COUNCIL ASSESSMENT REPORT

Panel Reference	PPSSCC – 635
DA Number	DA-24-00133
LGA	Blacktown
Proposed Development	Demolition of existing structures and construction of a place of public worship including a community hall, a 12-guest accommodation building, a souvenir shop and car parking for 178 vehicles.
Street Address	50 Stony Creek Road, Shanes Park
Applicant/Owner	The Trustee for Stimson & Baker Unit Trust / Shree Swaminarayan Mandir Vadtaldham Sydney Inc
Date of DA lodgement	19 September 2024
Number of Submissions	13
Recommendation	Refusal, for the reasons listed in this report.
Regional Development Criteria - Schedule 6 of SEPP (Planning Systems) 2021	CIV (\$21,806,542) > \$5M - Private infrastructure and community facilities
List of all relevant s4.15(1)(a) matters	• Environmental Planning and Assessment Act 1979 • State Environmental Planning Policy (Biodiversity and Conservation) 2021 • State Environmental Planning Policy (Planning Systems) 2021 • State Environmental Planning Policy (Resilience and Hazards) 2021 • State Environmental Planning Policy (Transport and Infrastructure) 2021 • State Environmental Planning Policy (Sustainable Buildings) 2022 • Blacktown Local Envir

Proposed Site Plan
1 : 500

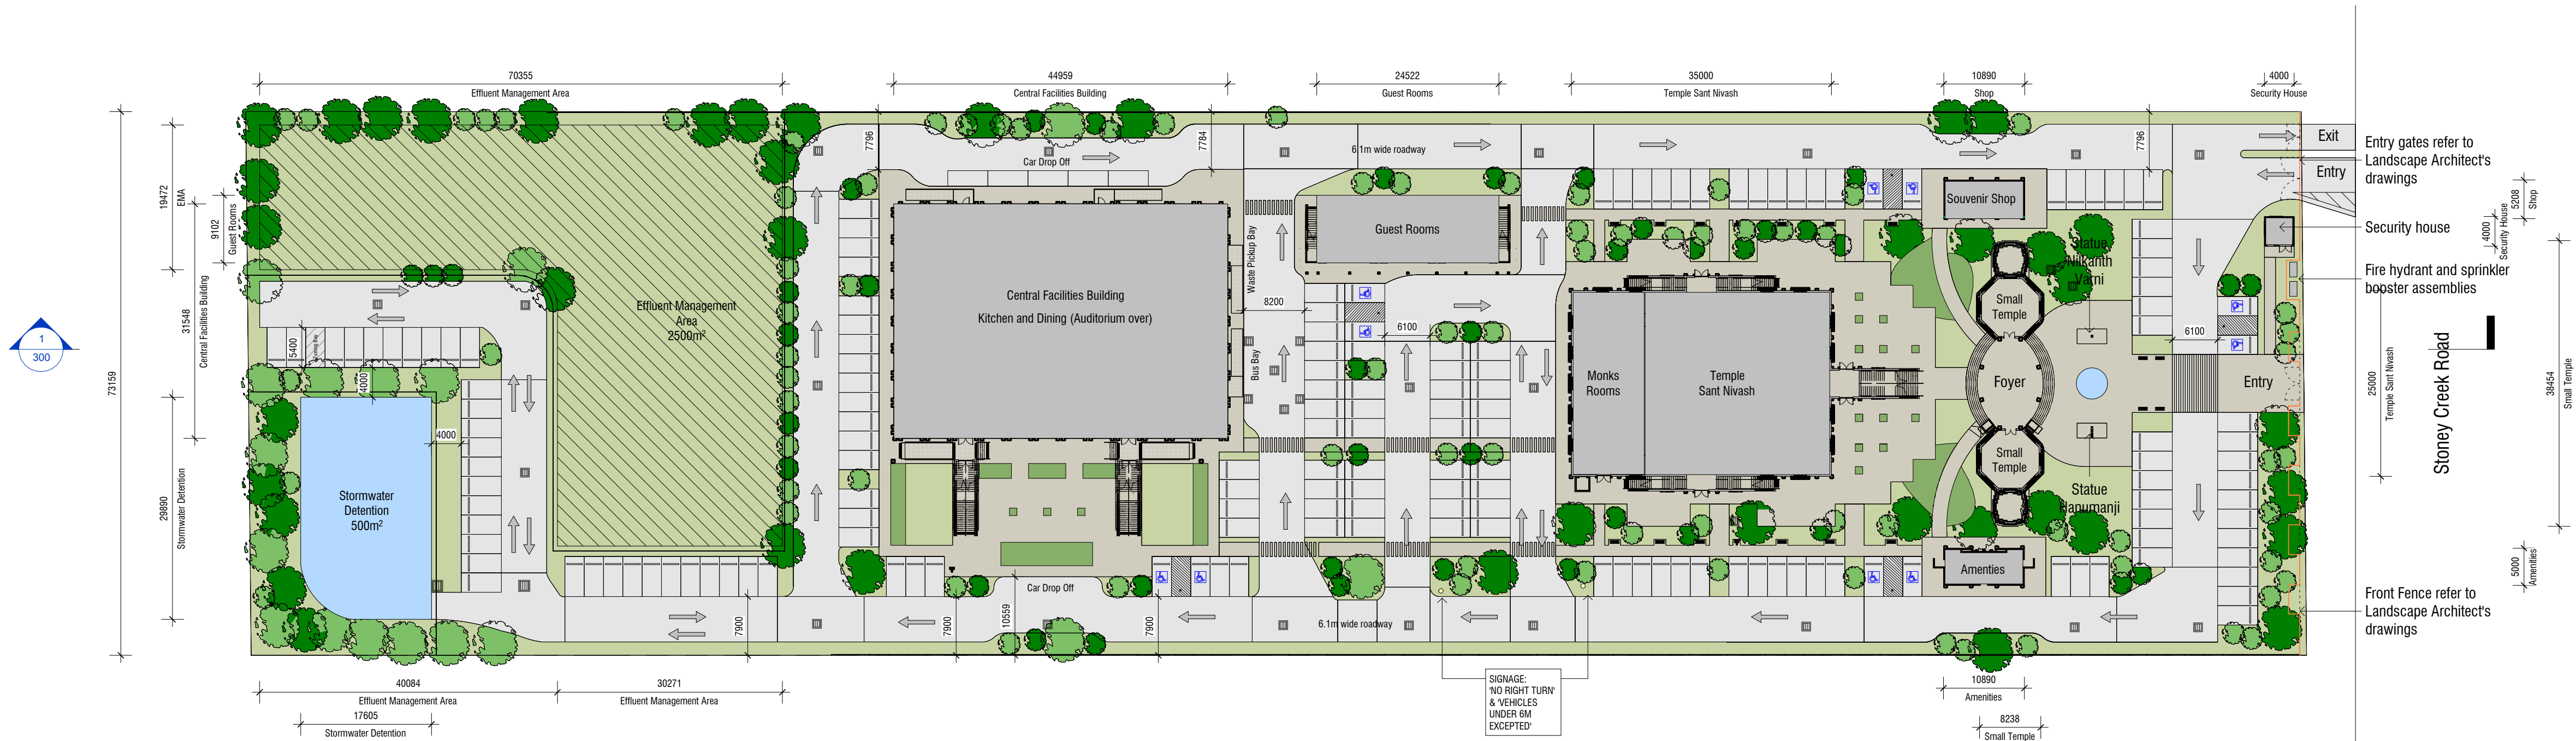
- 8.1 Parking provision is provided throughout the site for 167 spaces (according to the revised Parking and Traffic Impact Assessment Ref: 24-003-REP-2 prepared by Stanbury Traffic Planning and dated 9 July 2025), although the architectural plans show 174 spaces and the draft plan of management 178.
- 8.2 The main vehicular access is separated from the pedestrian entrance, at the northern side of the property.
- 8.3 During 10 special events per year, shuttle buses will be provided from 3 pick-up points with proposed parking locations at:
 - 8.3.1 135 Shane Park Road, Shanes Park (current place of public worship),
 - 8.3.2 31 Stanley Street Shanes Park (residential site), and
 - 8.3.3 213 - 224 St Mary's Road, Berkshire Park (residential site).

Site Plan - Landscape and Mandir Precinct

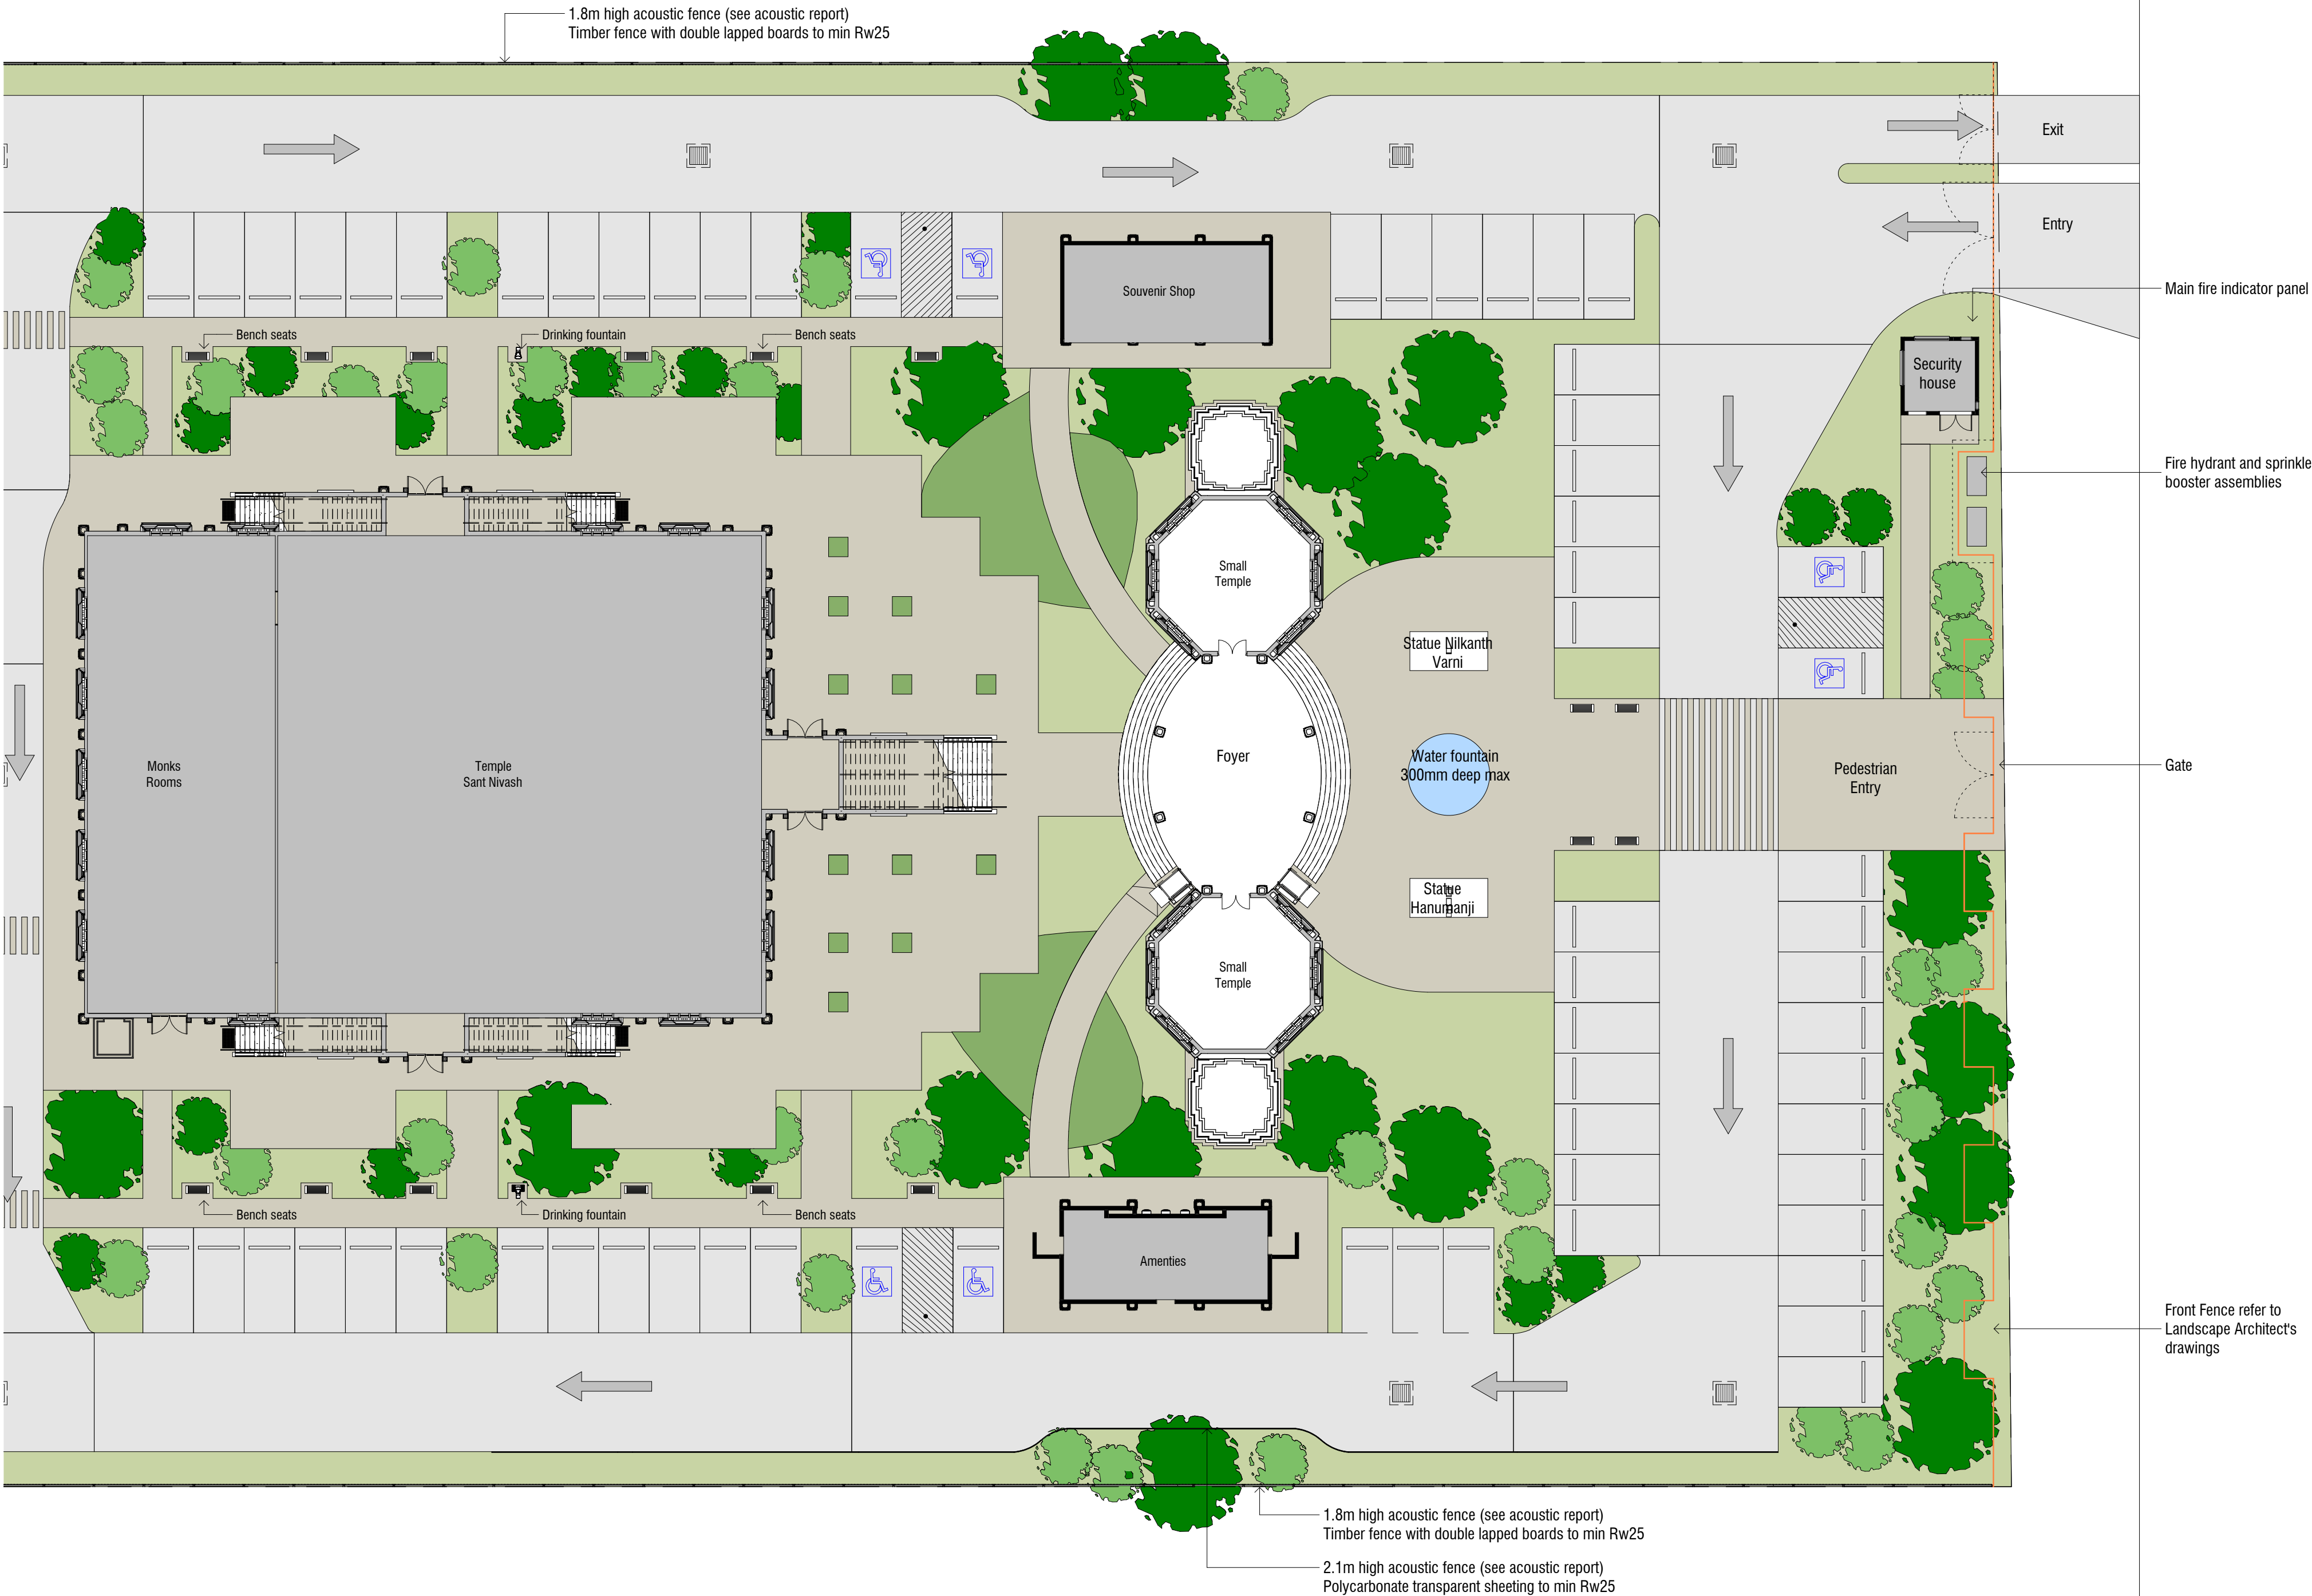
- 2.1.3 Two statues are also proposed between the front boundary and entry foyer. Refer to details on attachment 5 Drawing No. JA2277-L100 Issue 5. These statues are proposed to be 6m tall (increased from 5.6m from the base in the original design).
